MAP OF HELL'S KITCHEN NEIGHBORHOOD

# Conceptual Phase

# Preliminary Design

# Community Amenity

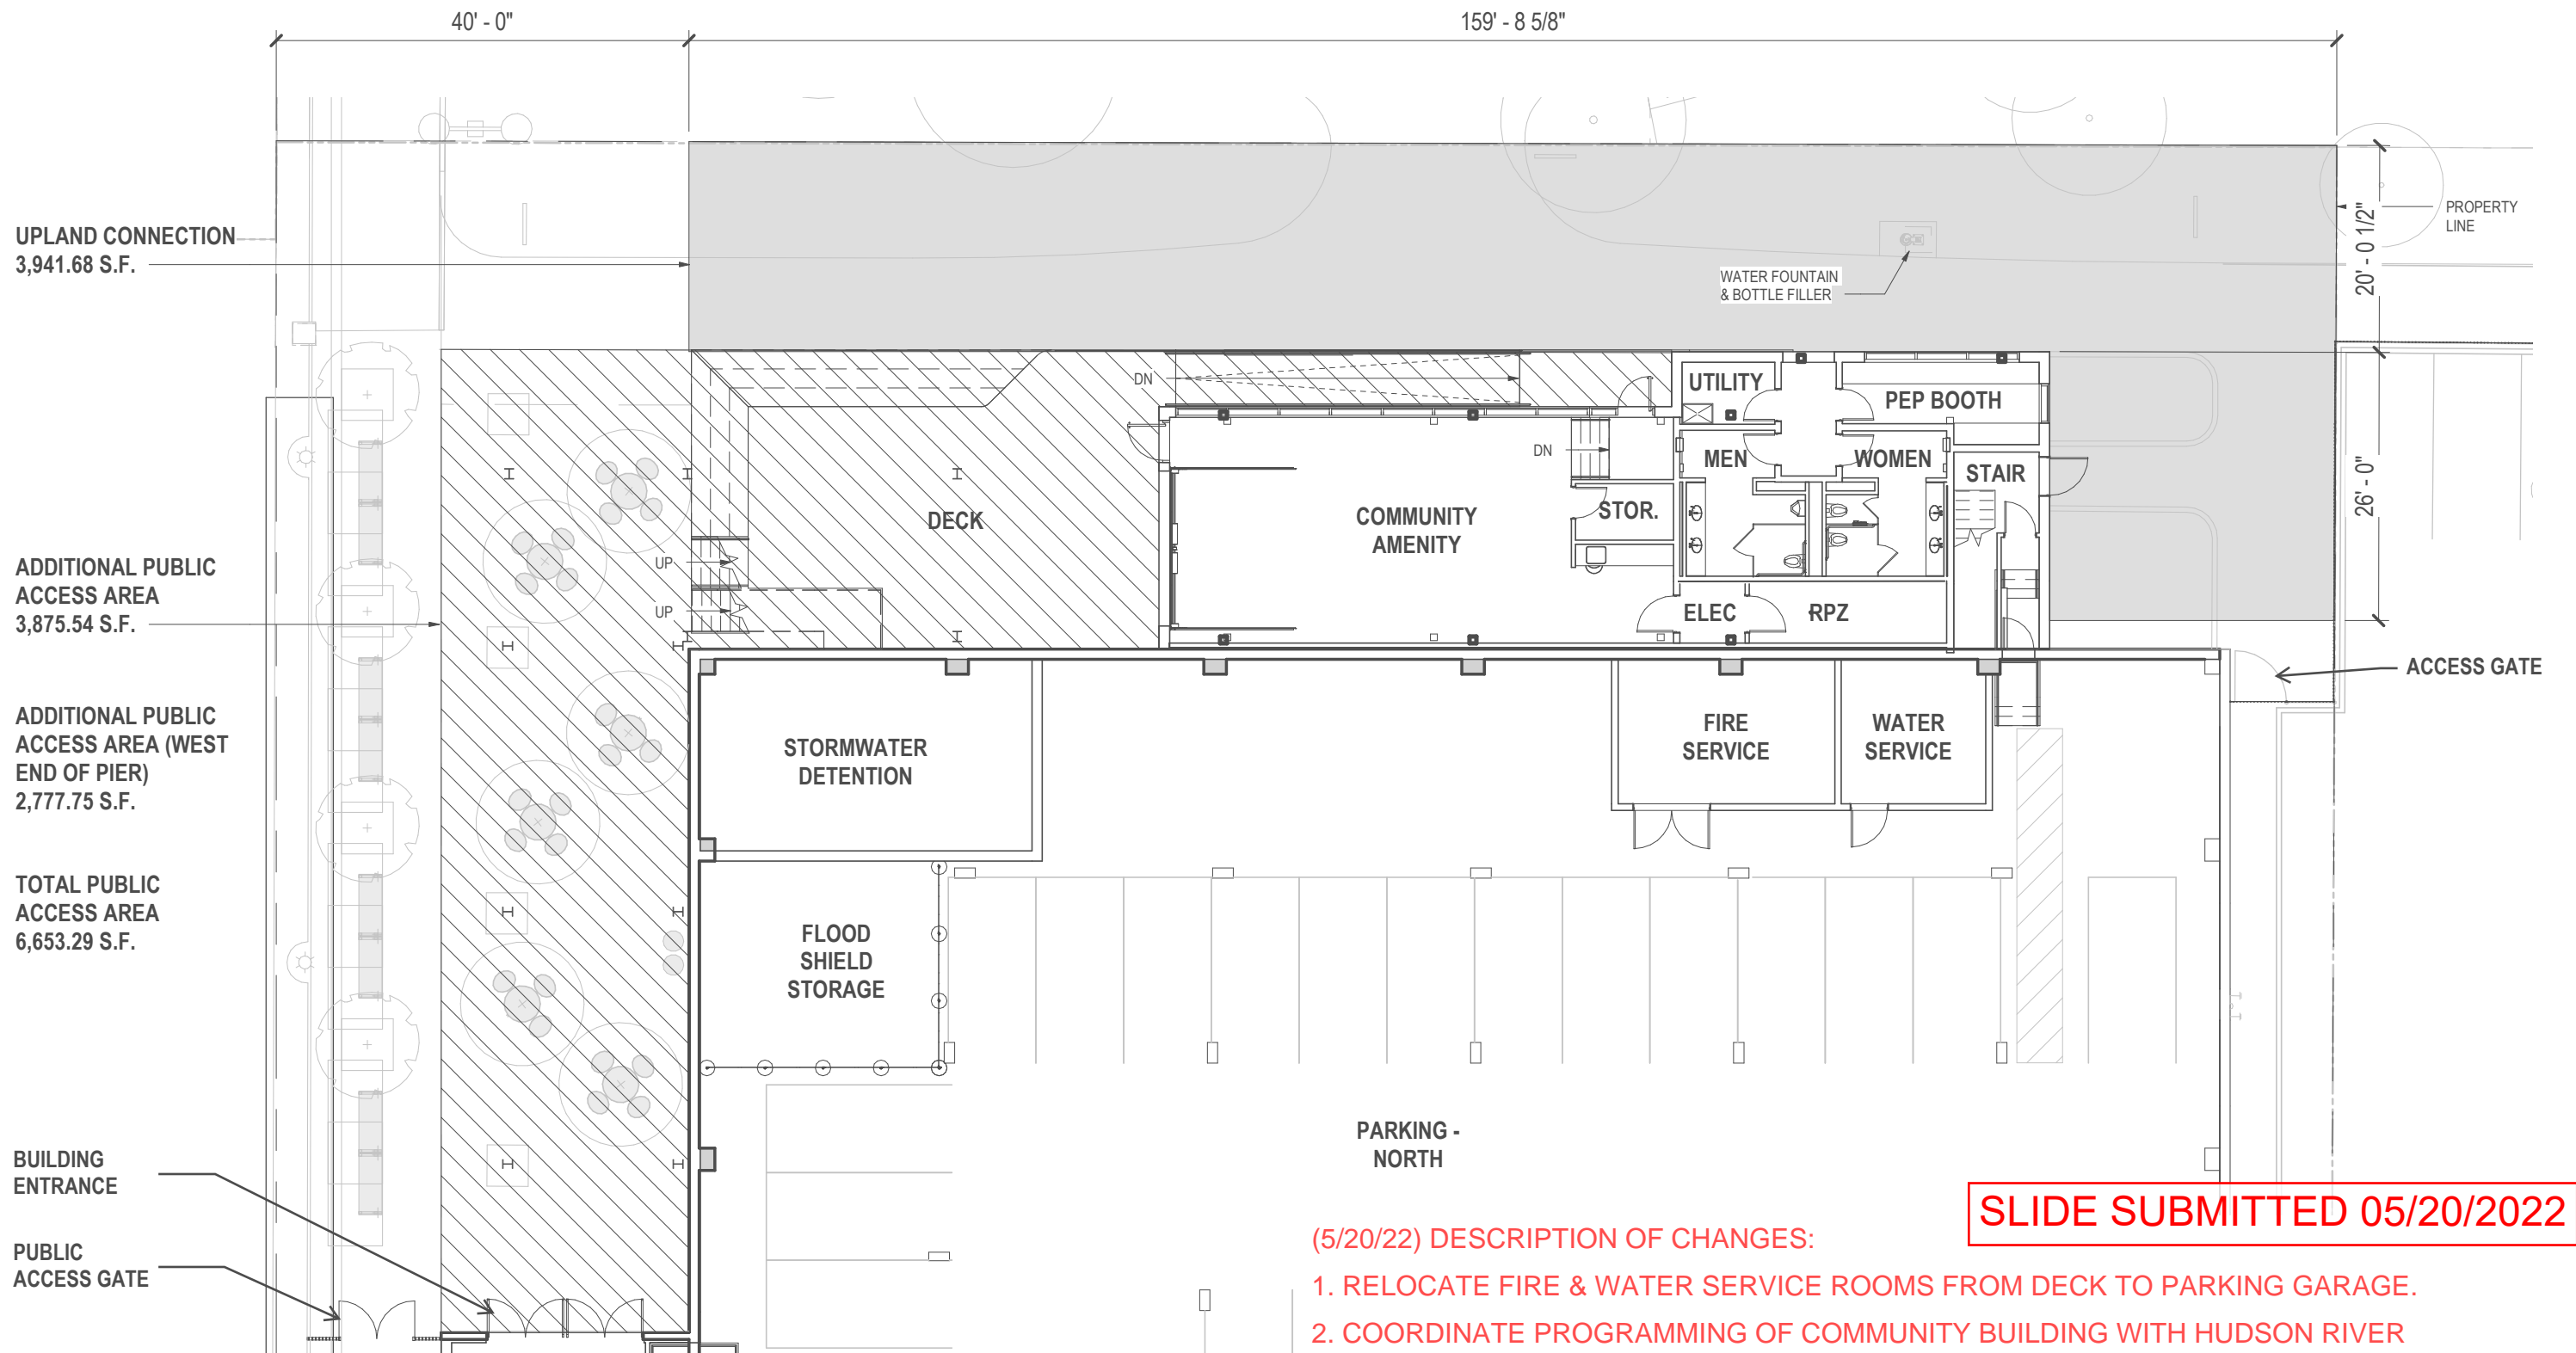
(5/20/22) DESCRIPTION OF CHANGES:

1. RELOCATE FIRE & WATER SERVICE ROOMS FROM DECK TO PARKING GARAGE.
2. COORDINATE PROGRAMMING OF COMMUNITY BUILDING WITH HUDSON RIVER PARK AUTHORITY. PROGRAM INCLUDES PEP BOOTH FOR PARK SECURITY, TWO RESTROOM FIXTURES PER SEX, AND KITCHENETTE & STORAGE WITHIN COMMUNITY AMENITY SPACE.
3. DECK EXPANDED AND EGRESS FROM STAGE RECONFIGURED.

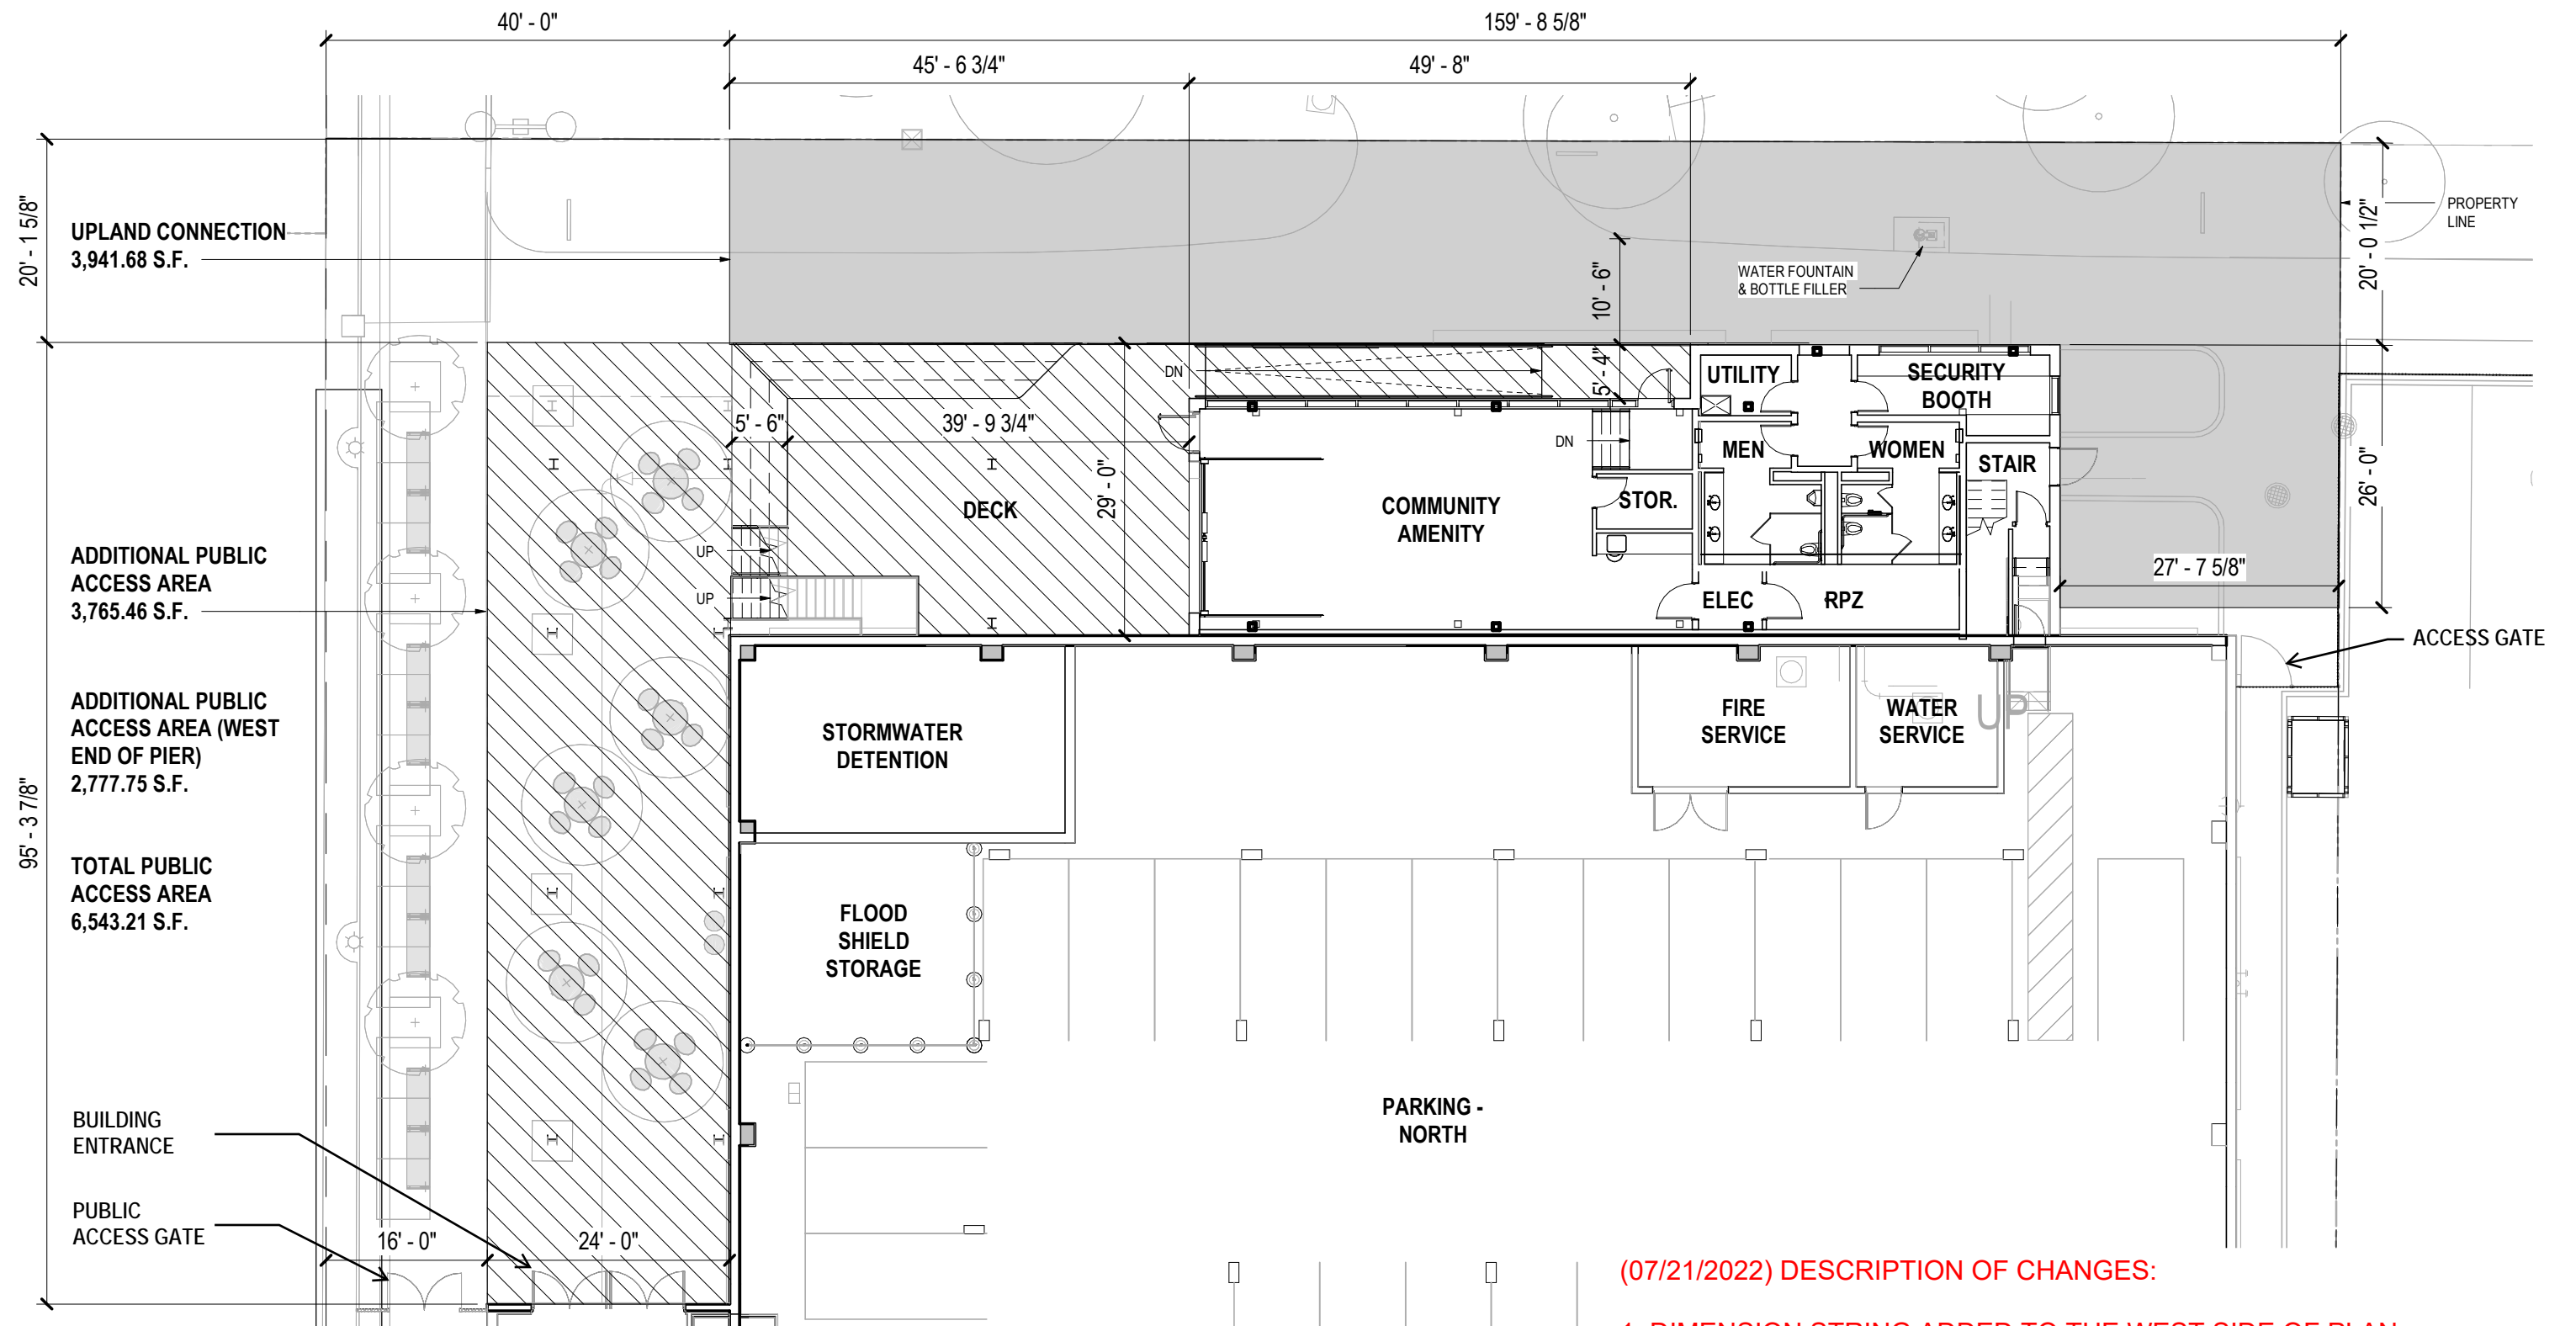
(07/21/2022) DESCRIPTION OF CHANGES:

1. DIMENSION STRING ADDED TO THE WEST SIDE OF PLAN.
2. WEST STAIR STAGE EGRESS AREA REMOVED FROM ADDITIONAL PUBLIC ACCESS AREA CALCULATION.

# Landscape & Site Furnishing

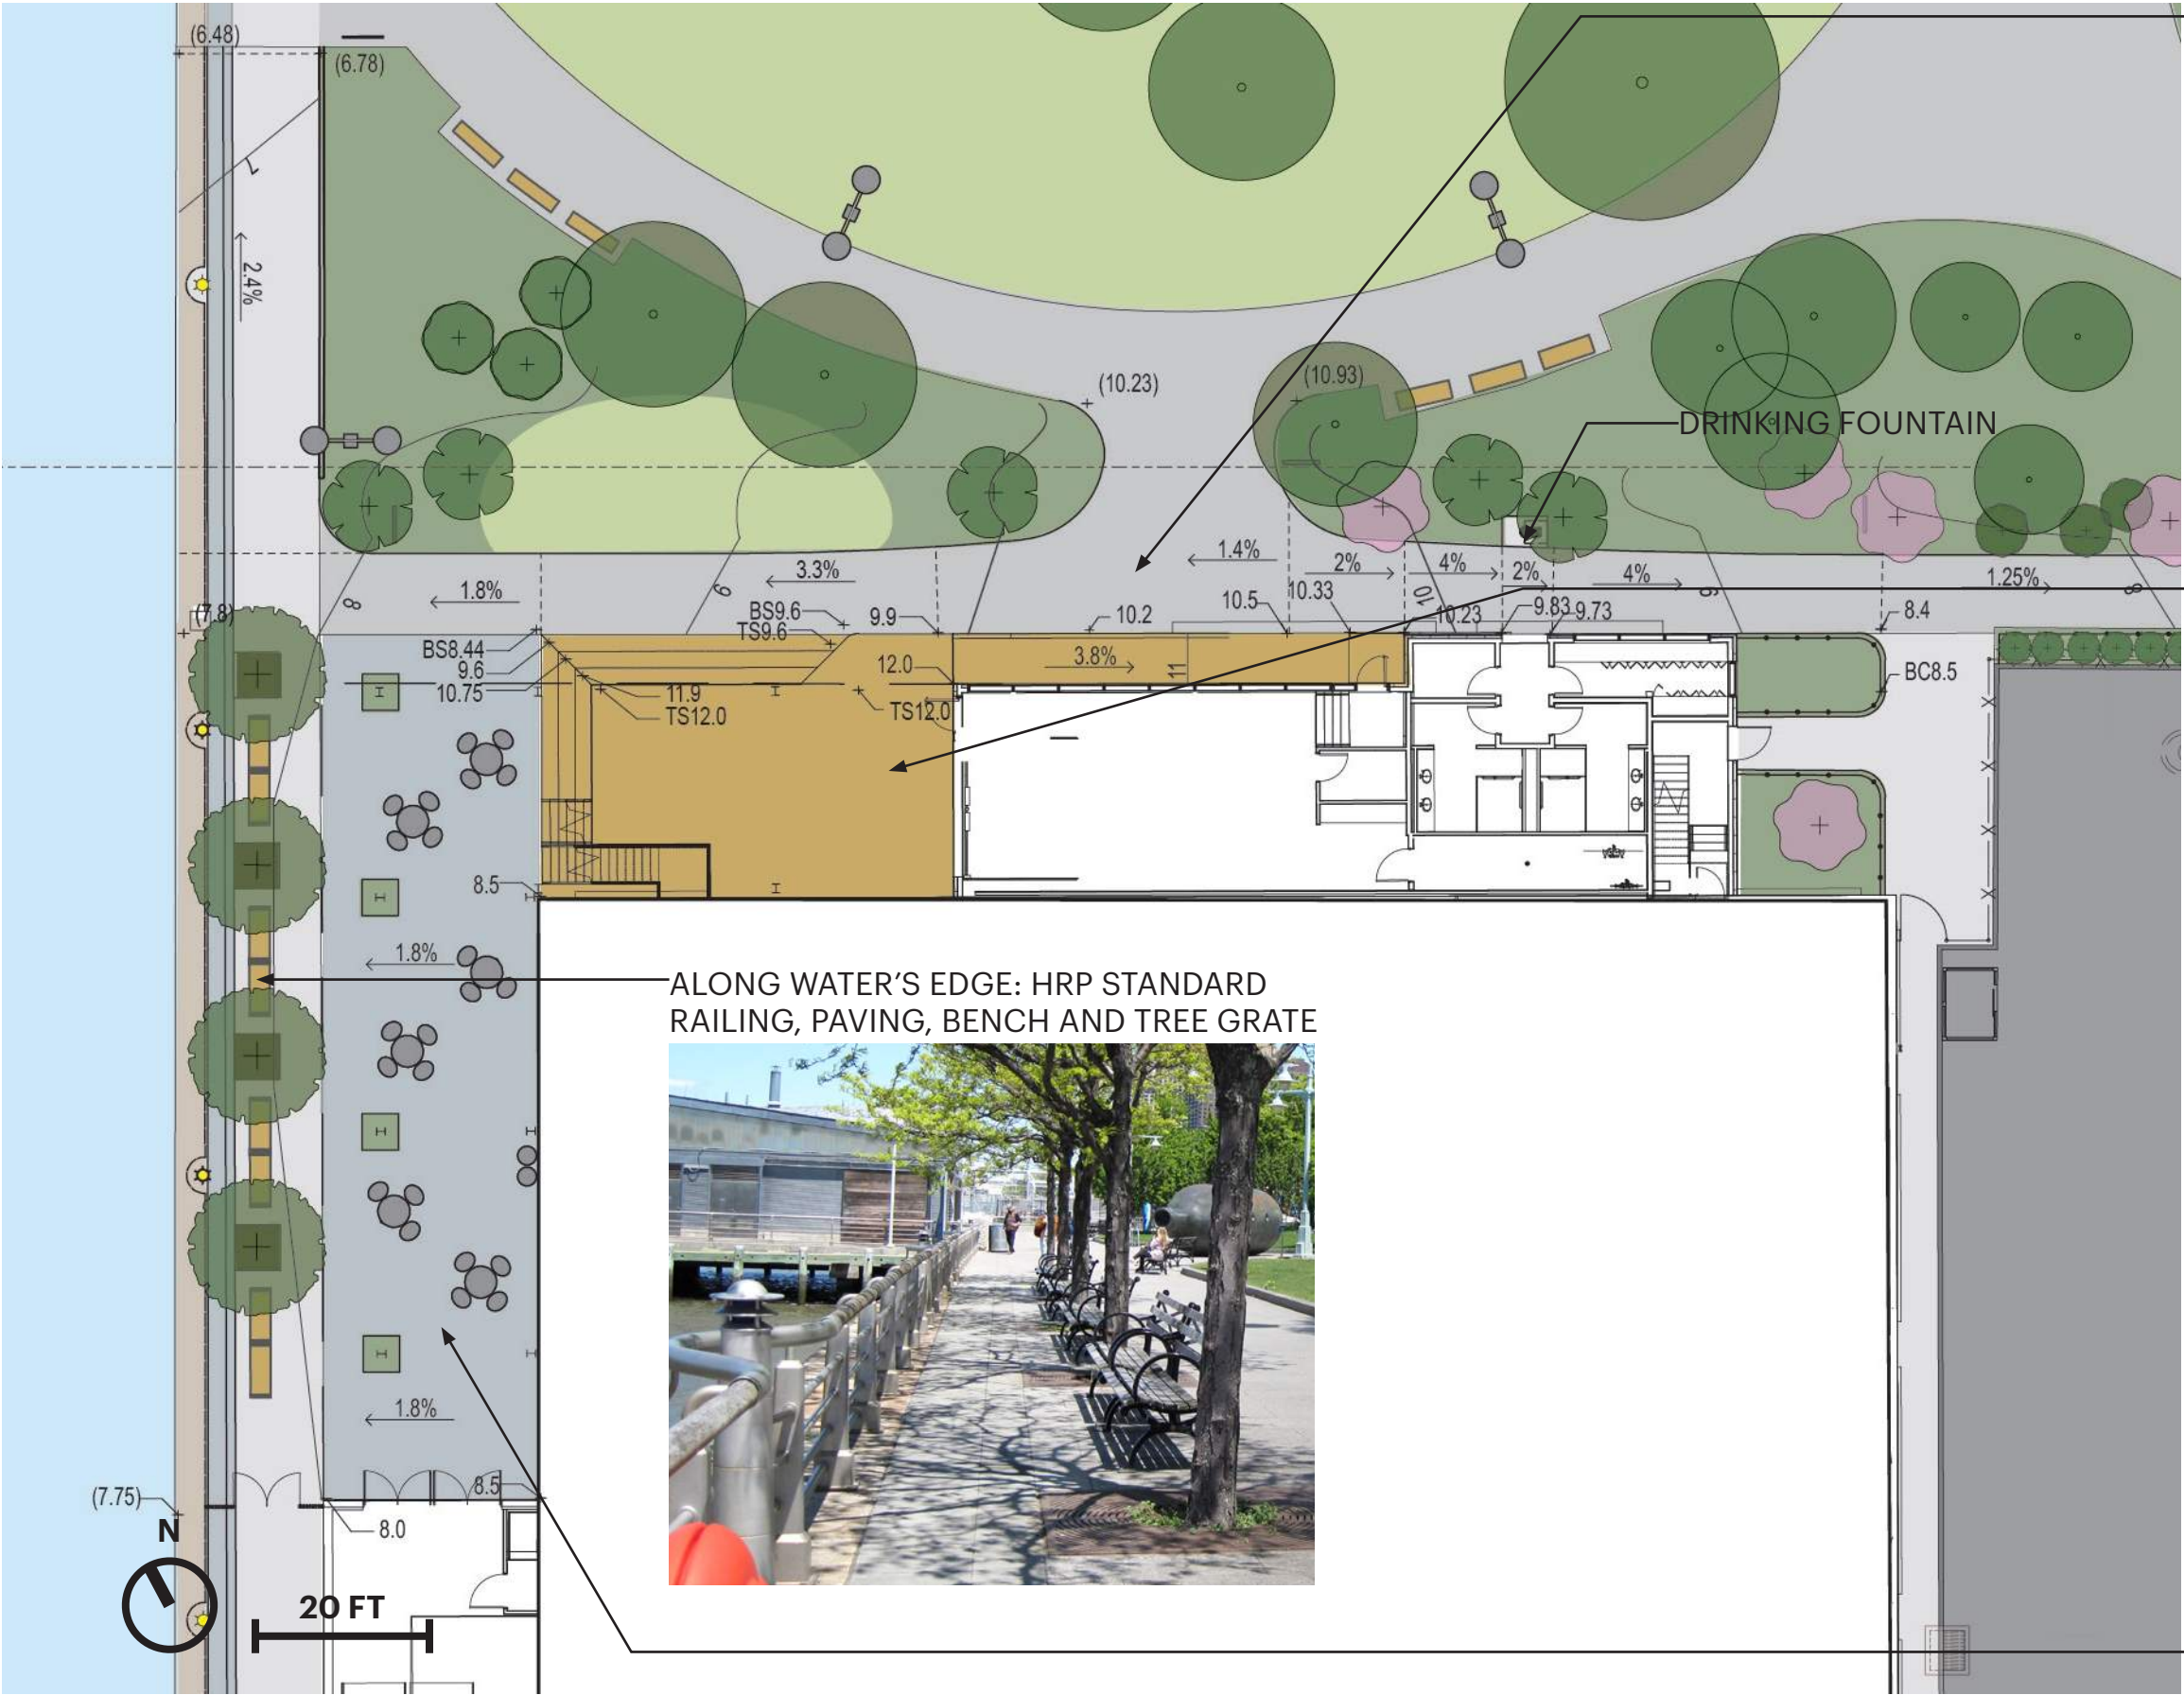
07/21/2022 DESCRIPTION OF CHANGES:

1. ADD TREE AT EAST PLANTING AREA NEAR STAGE STAIR EGRESS DOOR.
2. MOVE NORTHERN PORTION OF SITE FENCE SOUTH TO PROVIDE SCREEN PLANTINGS BETWEEN SITE FENCE AND WALKWAY.
